Technical Newsletter

SUBJECT: *TURNTABLE MOTOR BT TINTMASTER*

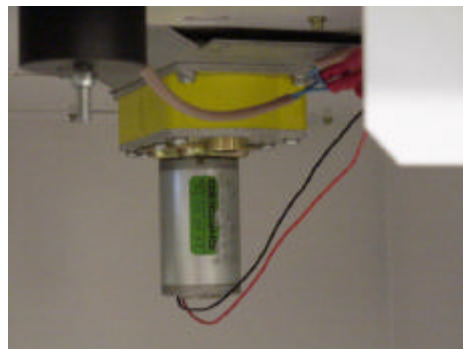
PROBLEM: Lifetime of the BT Tintmaster turntable motor is not long enough.

CAUSE: Colorants are very heavy or tixotrop or needs to be stirred more often then the normal setting of each 4 hour, 3 minutes

SOLUTION: The turntable motor of the BT Tintmaster 24 canisters is stronger and, for the above mentioned cases, will give a longer lifetime.

HOW: Take the normal turntable motor out, including the bracket.
Place the BT24 turntable motor and the new bracket in the same place.
(Part number: Motor 1861266-SP, Bracket 1808485-SP, 4 bolts M5x16)

Adjust the following setting with the Machtune program:

| 1. TURN HIGH PWM VALUE | from | 100 | to | 150 |
| 2. TURN LOW PWM VALUE | from | 65 | to | 100 |
| 3. TURN STOP (10 msec.) | from | 1 | to | 3 |
